Subject: Amendment No. 14 to Facility Operating License No. NPF-14 -  
 Susquehanna Steam Electric Station, Unit 1

PENNSYLVANIA POWER & LIGHT COMPANY  
ALLEGHENY ELECTRIC COOPERATIVE, INC.  
DOCKET NO. 50-387  
SUSQUEHANNA STEAM ELECTRIC STATION, UNIT 1  
AMENDMENT TO FACILITY OPERATING LICENSE

Amendment No. 14  
 License No. NPF-14

ATTACHMENT TO LICENSE AMENDMENT NO. 14  
FACILITY OPERATING LICENSE NO. NPF-14  
DOCKET NO. 50-387

Bases Figure B 3/4 3-1  
REACTOR VESSEL WATER LEVEL

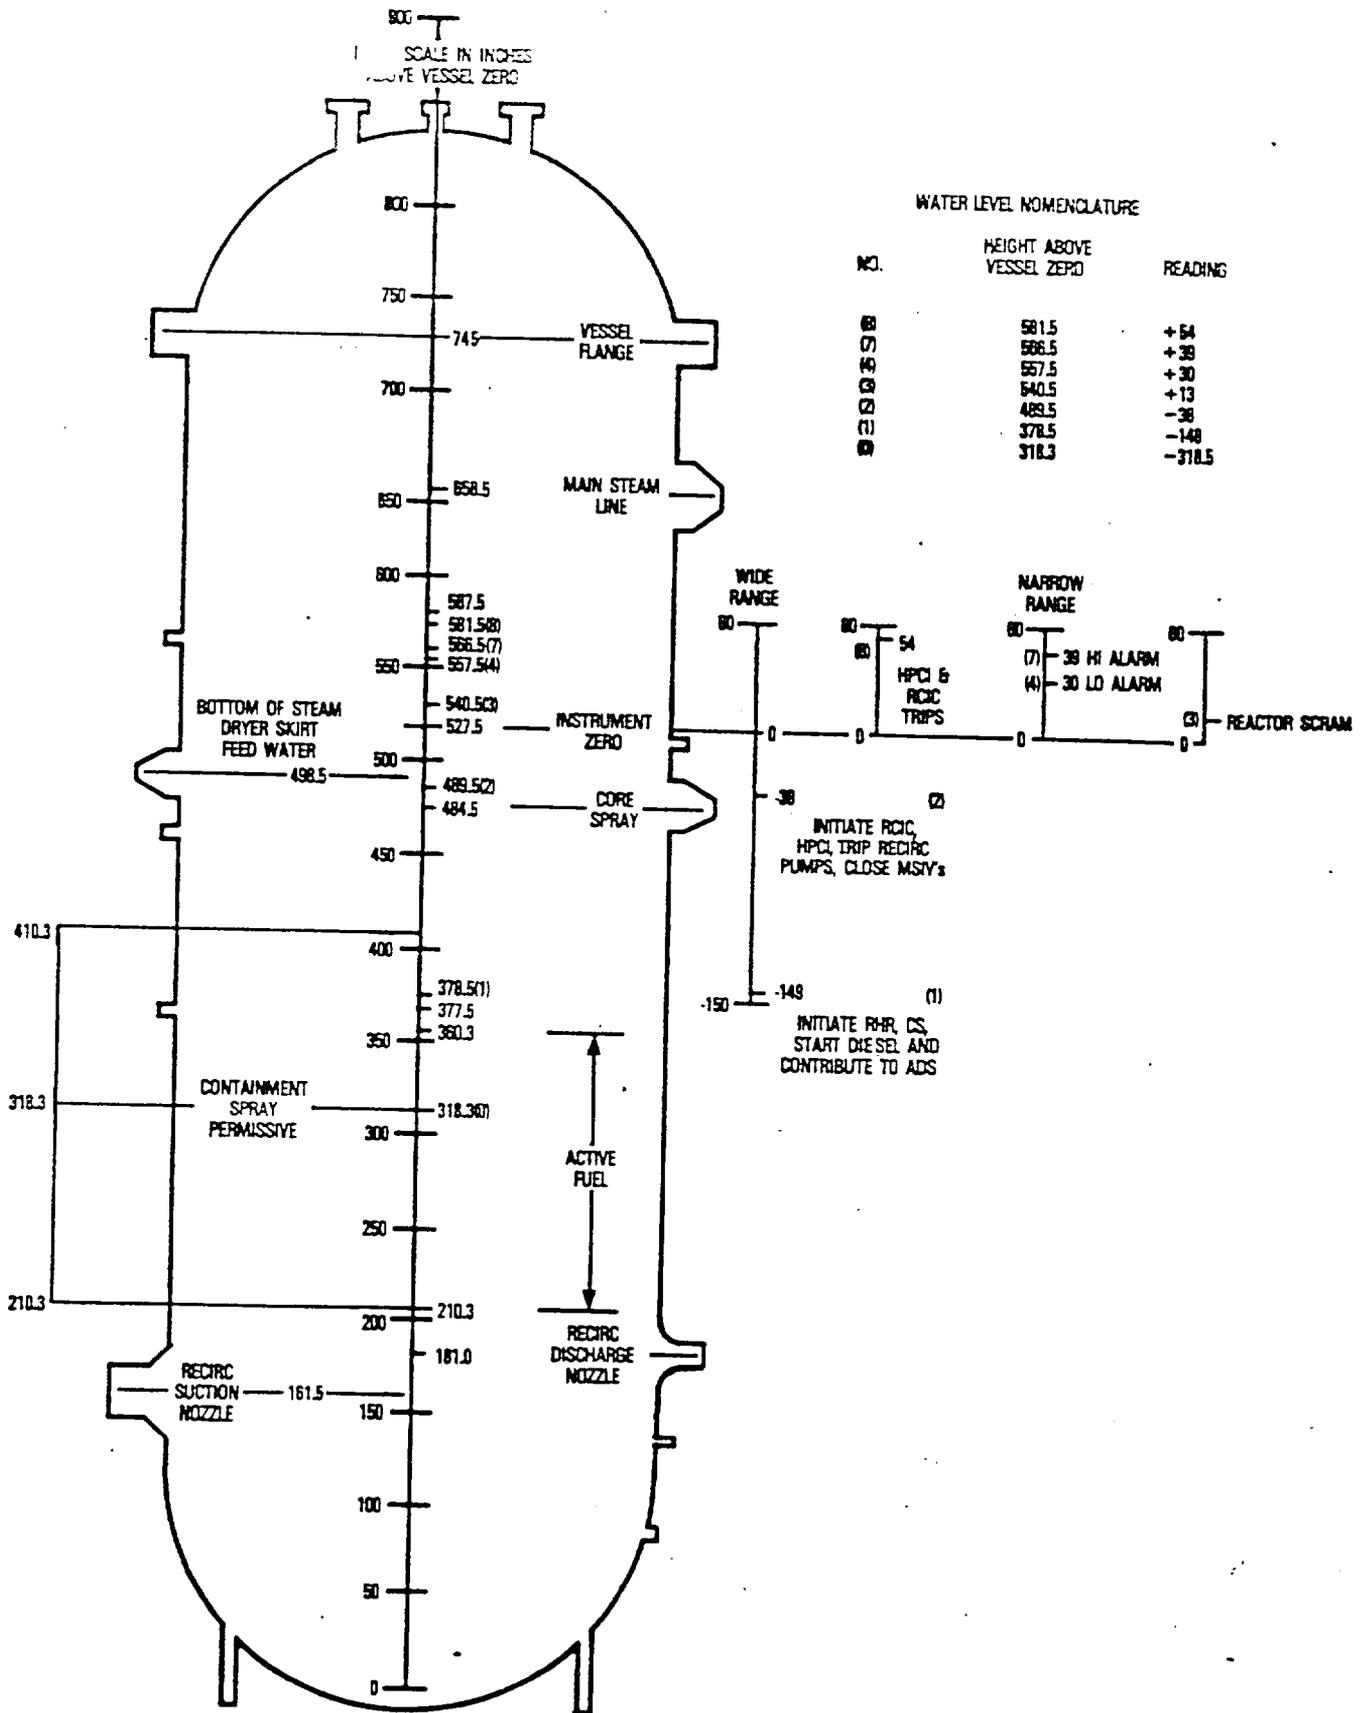
Several typographical errors were noted in Figure B3/4 3-1, and in various specifications which reference the "Semiannual Radioactive Effluent Release Report" or the "Annual Radiological Environmental Operating Report". The NRC staff has reviewed the changes proposed by the licensee and finds them acceptable on the basis that correction of the typographical errors provides clarification of the affected specifications.
